# The Calcutta Gazette

## APPENDIX.

### NOTICES TO MARINERS.

Reproduction of Portion of Chart N° 1263.

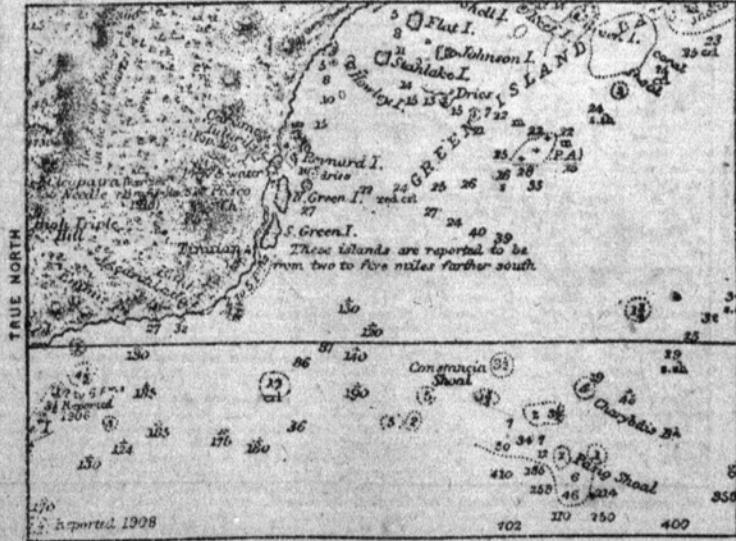
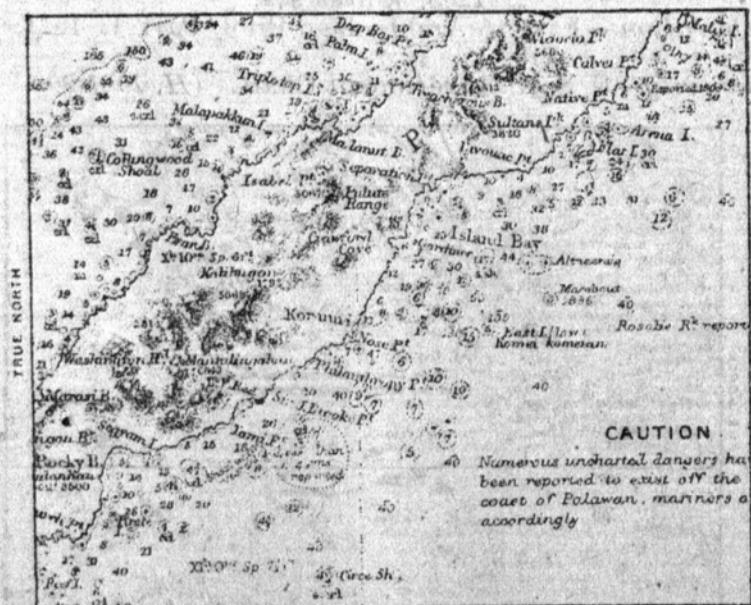
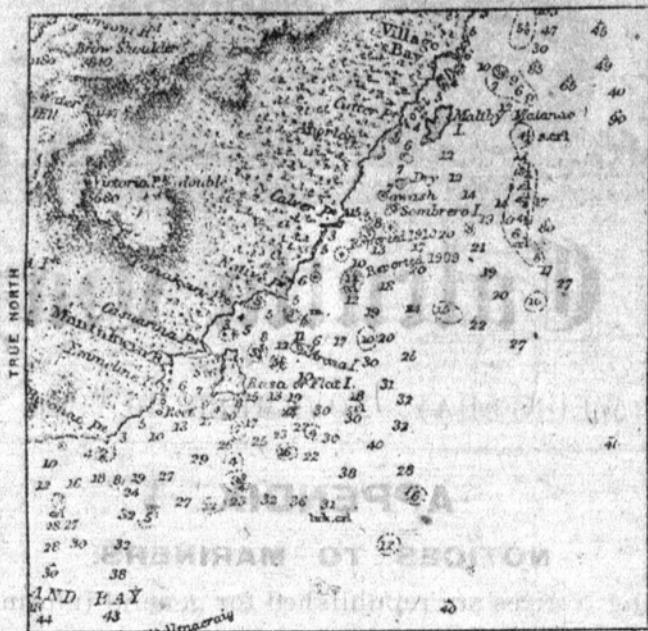
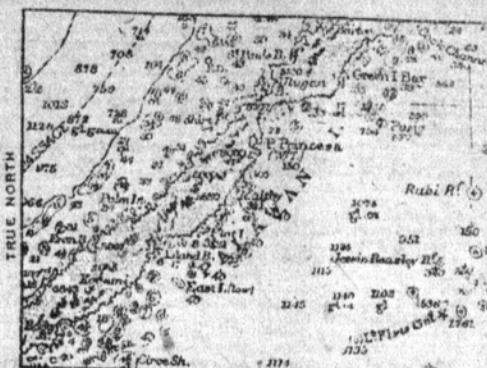
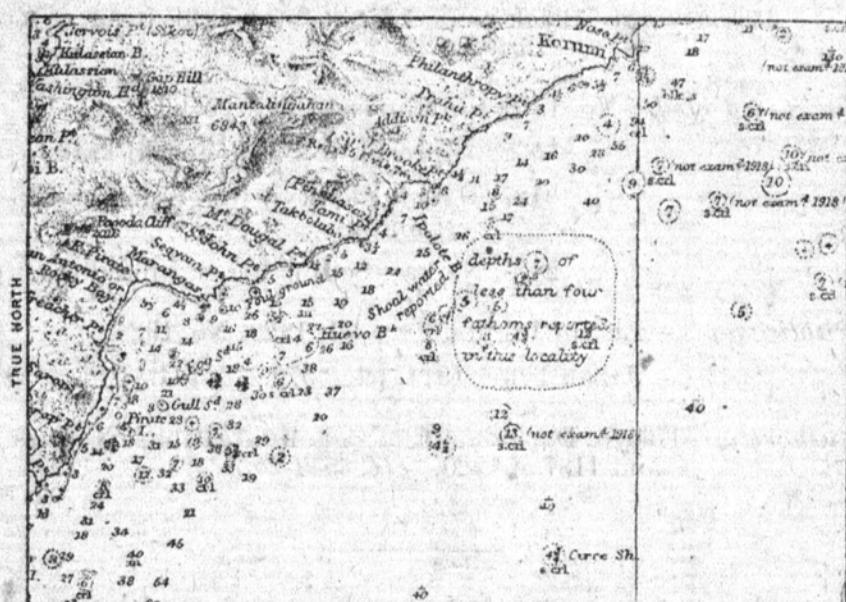
*Details.*—Amendments to the charts with regard to shoals between Green island bay and Coral bay, embodying the latest information, are shown on the accompanying reproductions of portions of charts Nos. 967, 2660b and 1263.

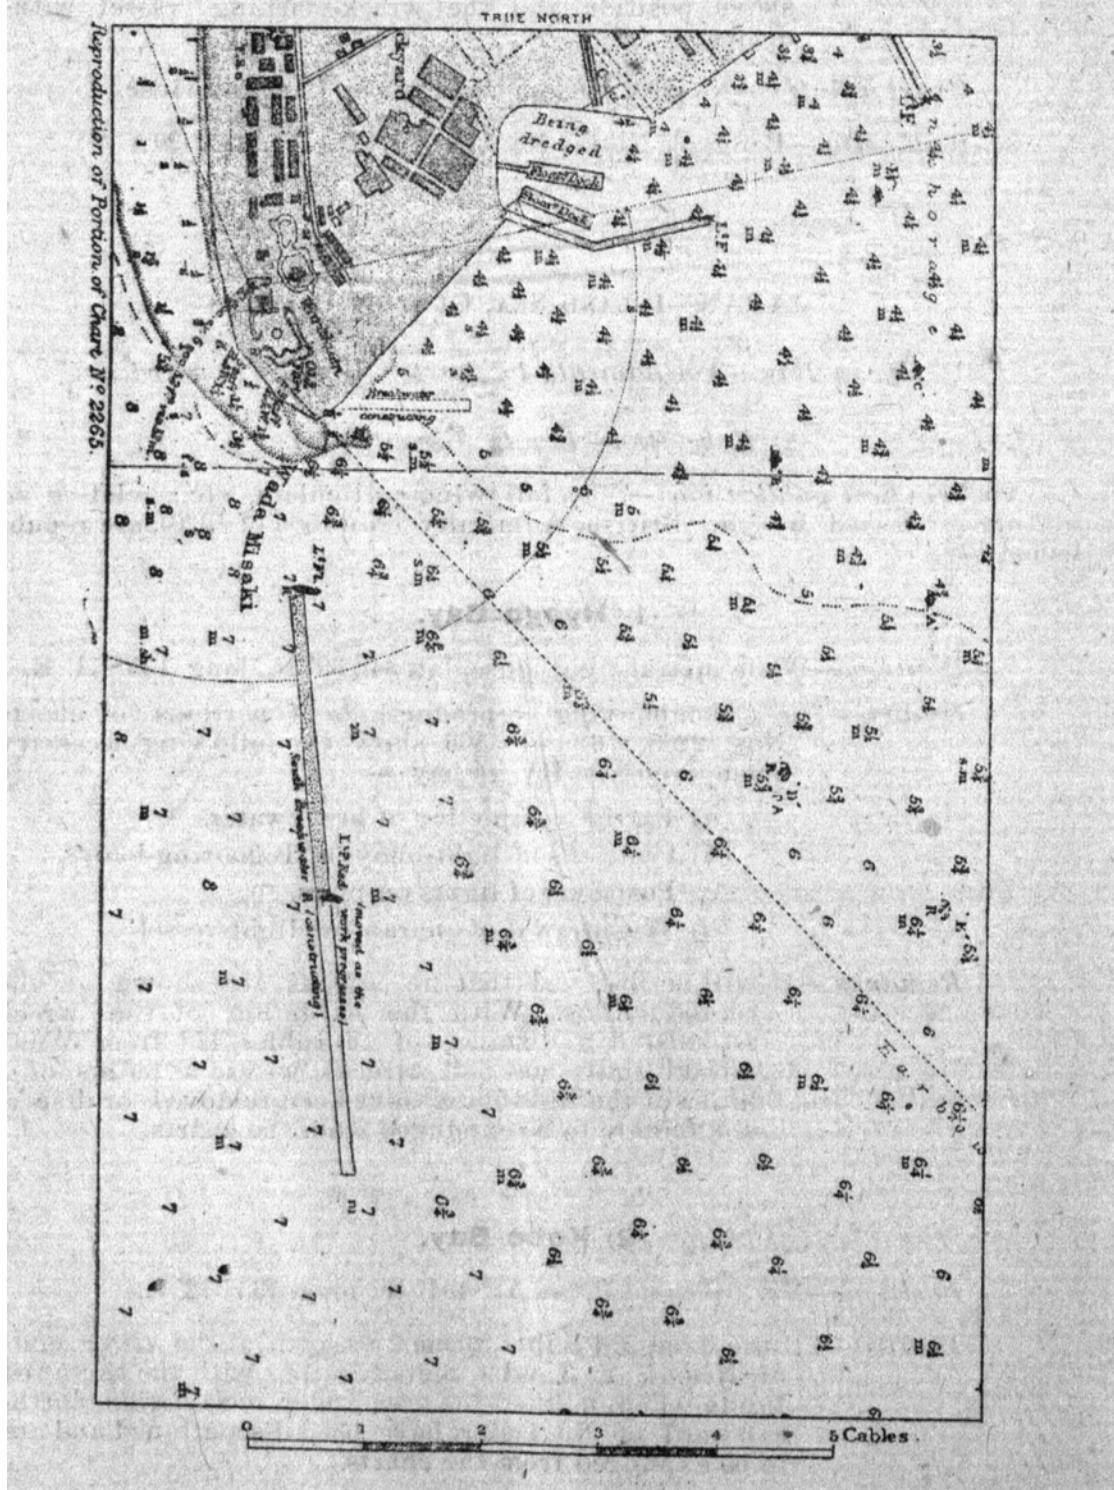
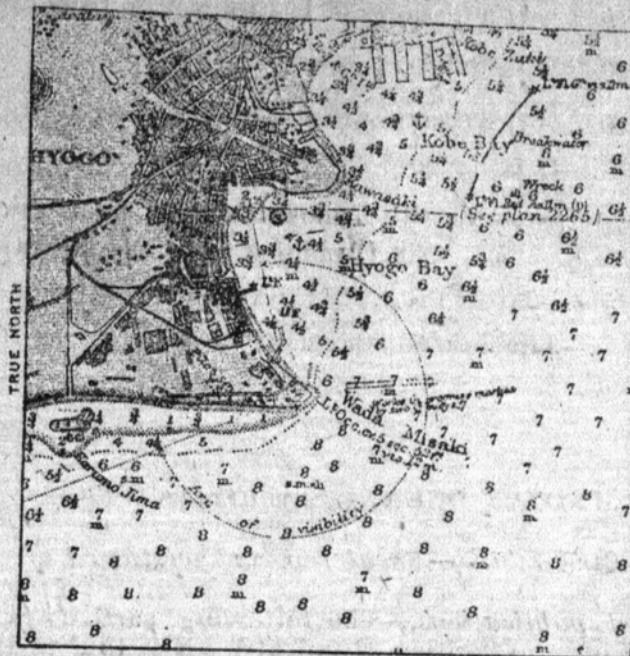
*Details.—The accompanying reproductions of portions of charts Nos. 2265, 16 and 3566 show the following necessary amendments in Hyogo bay:—*

- (a) Partial completion of breakwater.
- (b) Positions of light-buoys and mooring-buoys.
- (c) Positions of lights on piers.
- (d) Withdrawal of quarantine light-vessel.

*Remarks.—It will be observed that no wrecks are shown on the reproductions. With the exception of the wreck situated at a distance of 16 cables,  $47^{\circ}$  from Wada misaki lighthouse, all wrecks within a radius of 2 miles of the lighthouse have been removed or dispersed and are to be expunged from the charts.*

Reproduction of Portions of Chart N° 967.

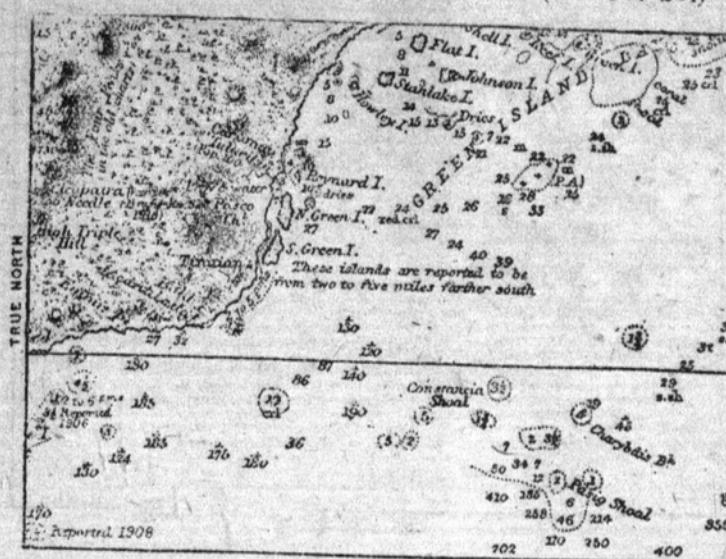
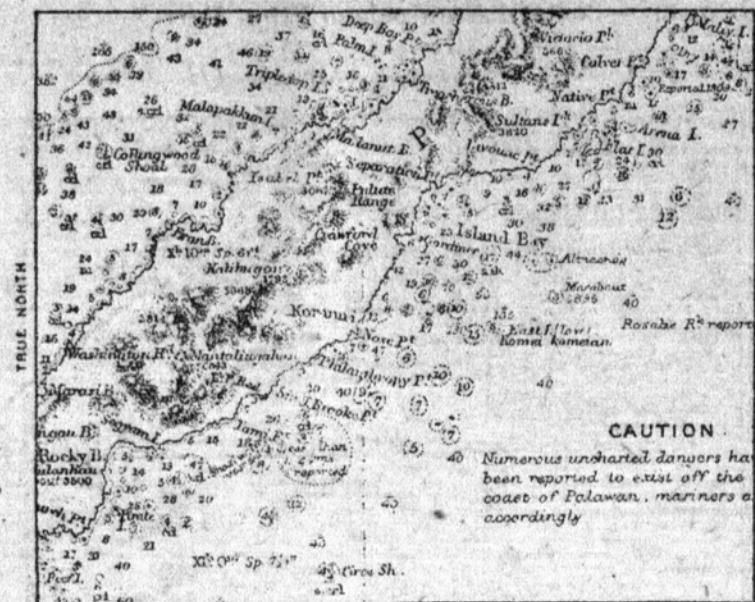
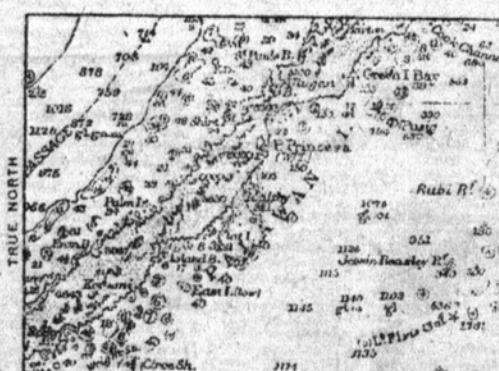
*Details.*—Amendments to the charts with regard to shoals between Green island bay and Coral bay, embodying the latest information, are shown on the accompanying reproductions of portions of charts Nos. 967, 2660b and 1263.

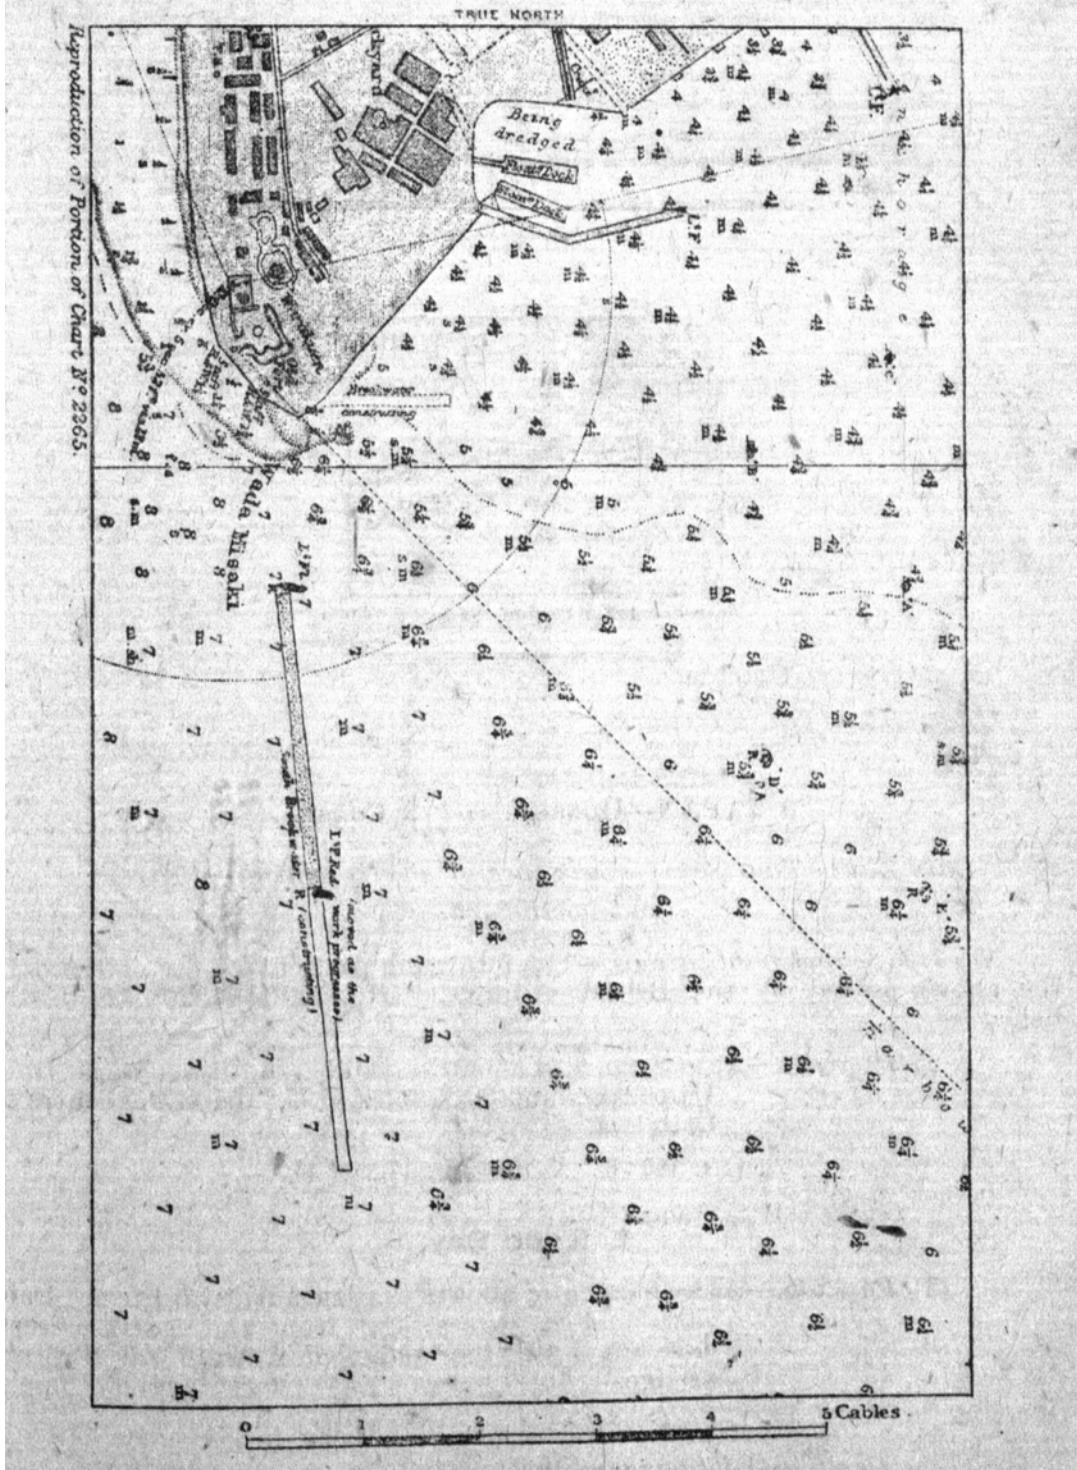
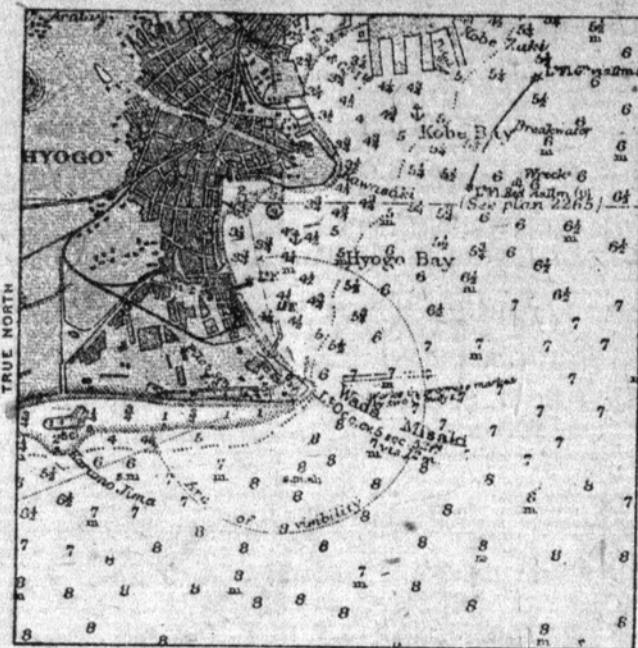
*Details.*—The accompanying reproductions of portions of charts Nos. 2265, 16 and 3566 show the following necessary amendments in Hyogo bay:—

Reproduction of Portions of Chart N° 967.

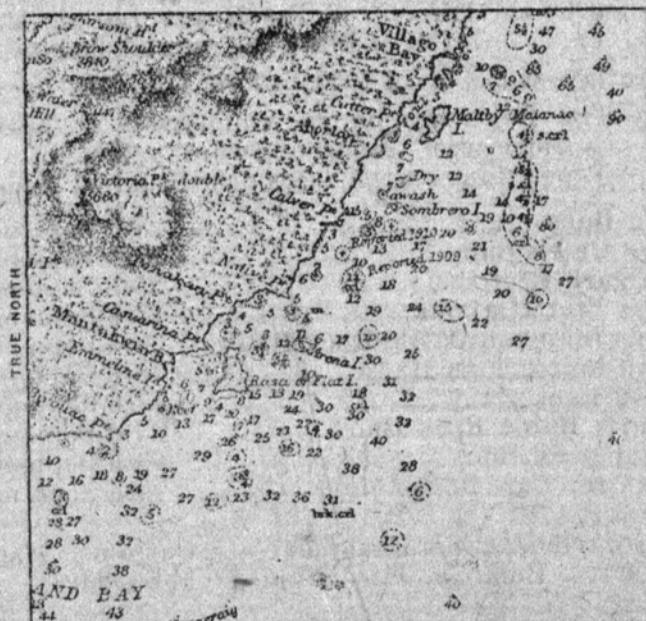
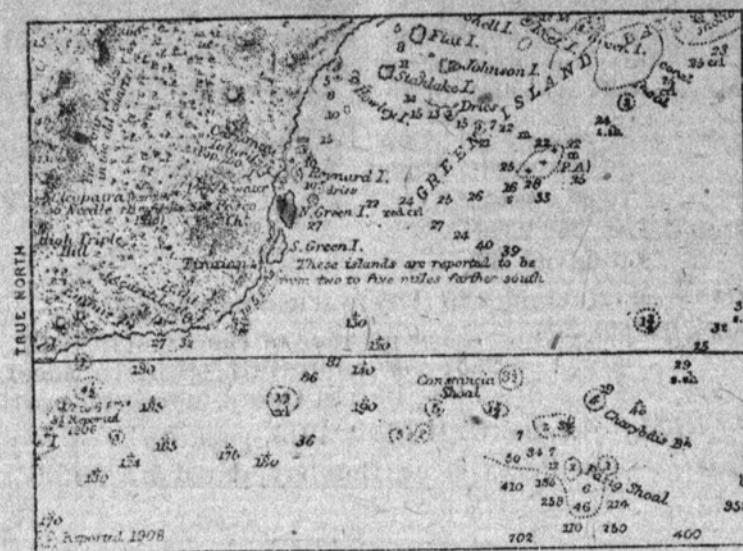
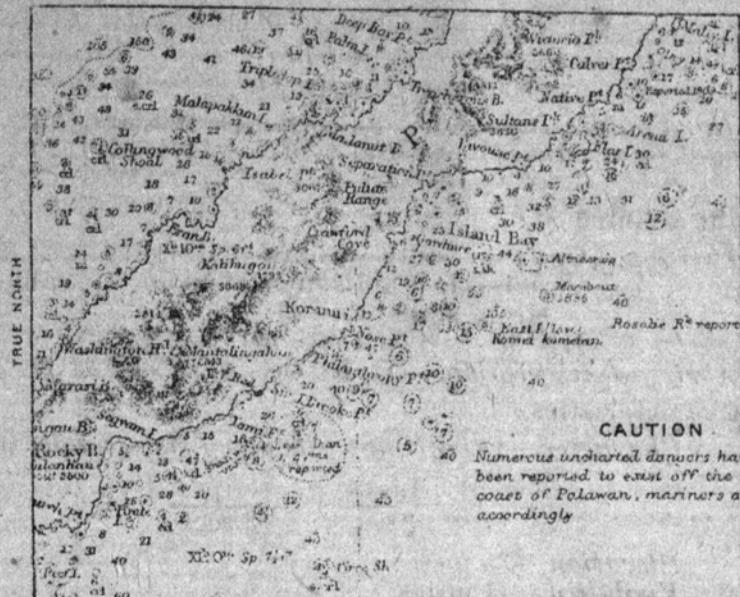
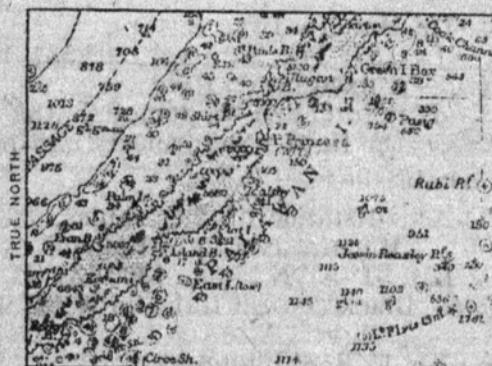
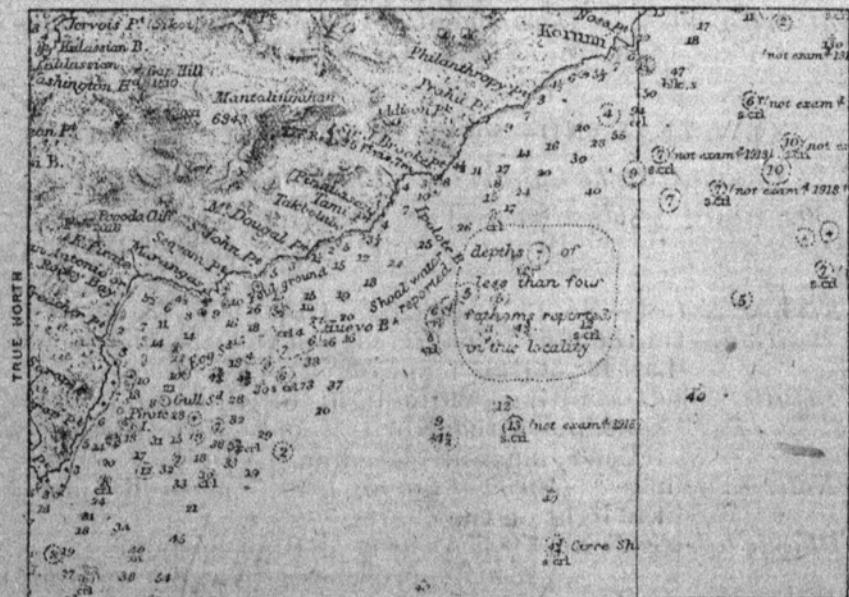
*Details.*—Amendments to the charts with regard to shoals between Green island bay and Coral bay, embodying the latest information, are shown on the accompanying reproductions of portions of charts Nos. 967, 2660b and 1263.

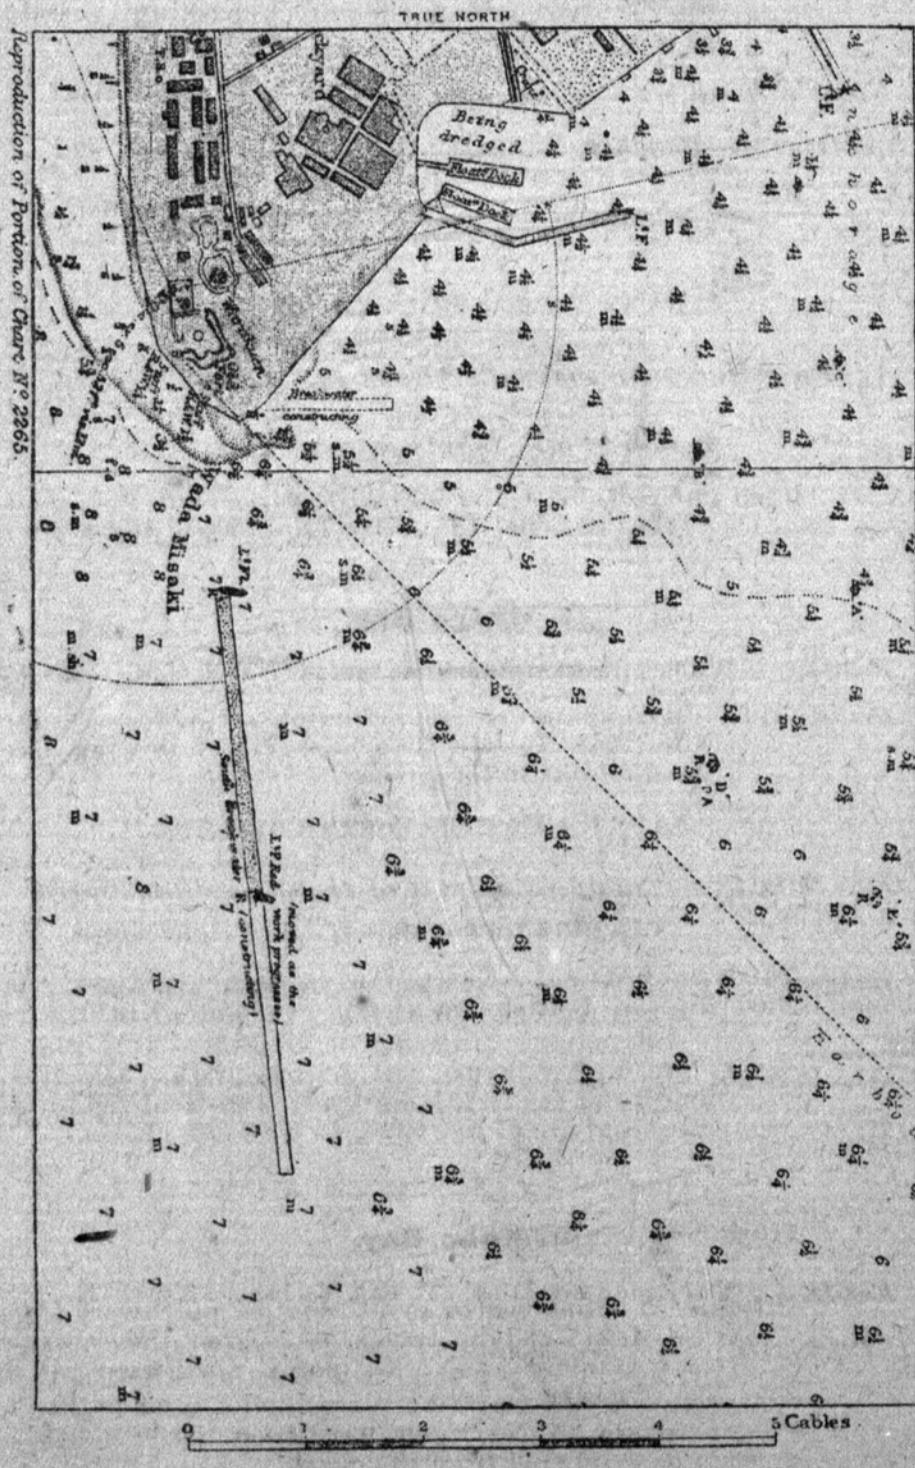
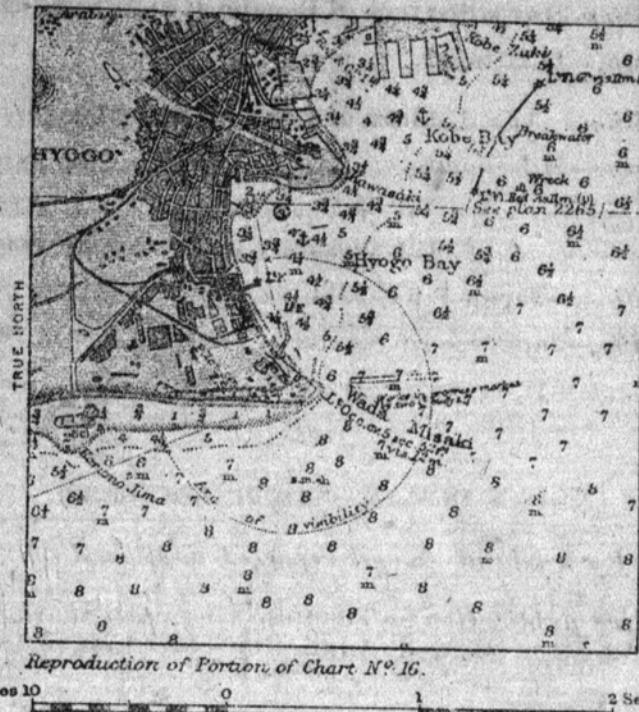
*Details.*—The accompanying reproductions of portions of charts Nos. 2265, 16 and 3566 show the following necessary amendments in Hyogo bay:—
